**STORMWATER MANAGEMENT PLAN**

City of Florence  
Public Works Department

# STORMWATER DESIGN REPORT

FOR  
*SPRUCE STREET LID*  
FLORENCE, OR

# Figure 5-2: Florence Northeast Region

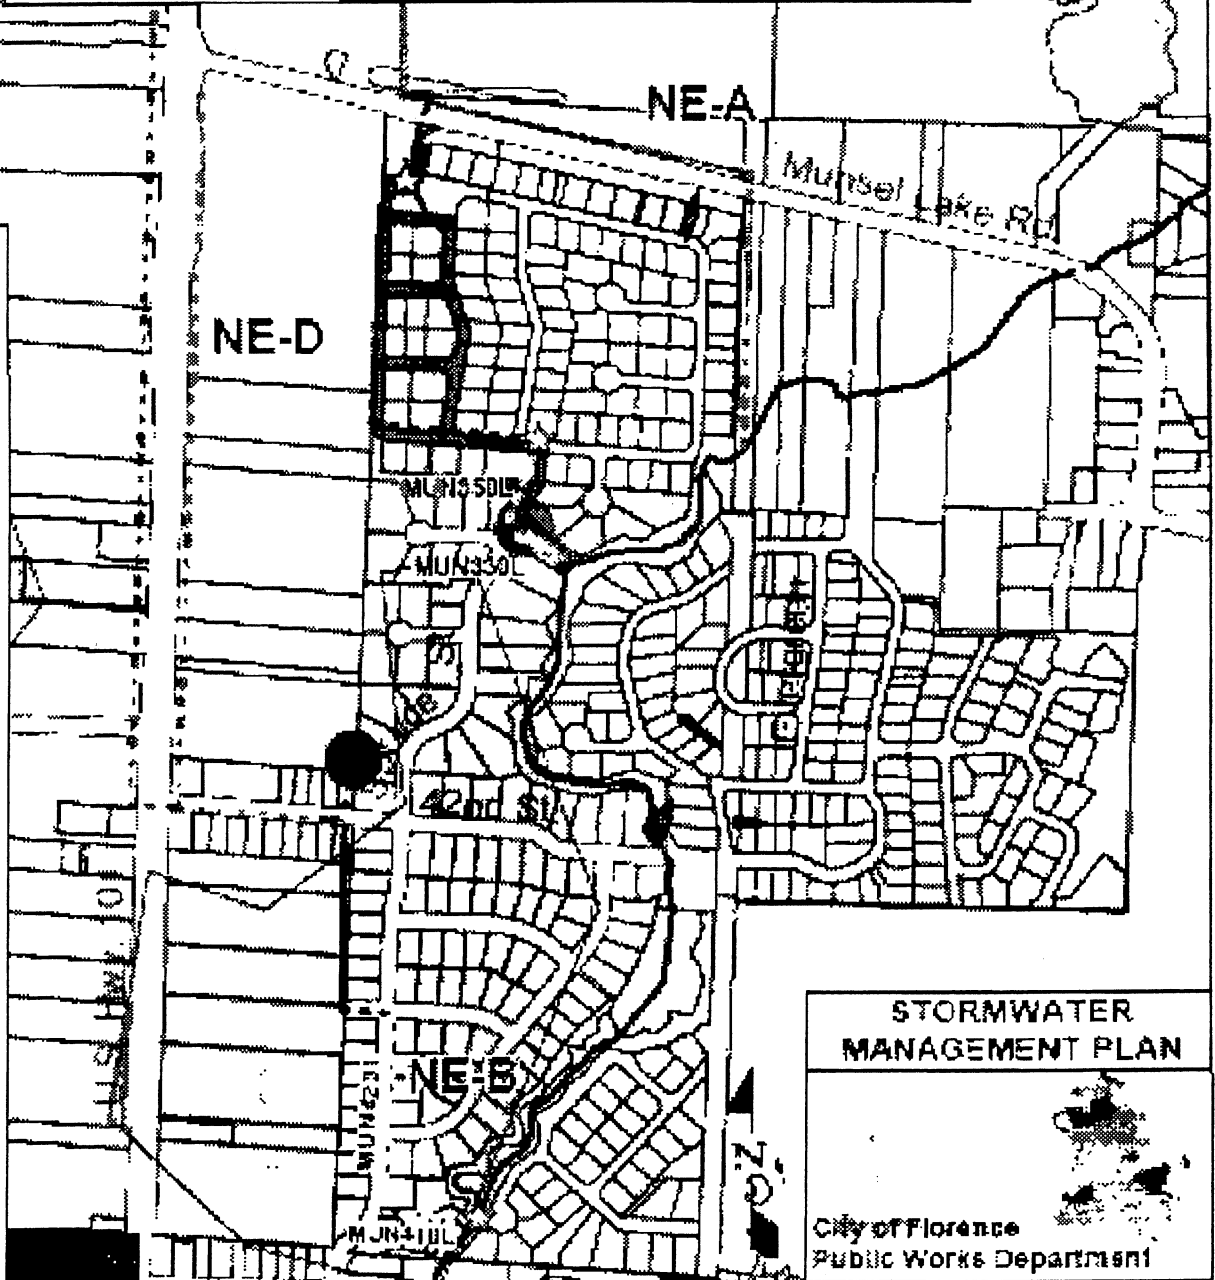
Modify Figure 5-2 to show the design in Figure 4.1 of the "Stormwater Design Report," July 2006, attached as Exhibit E-1
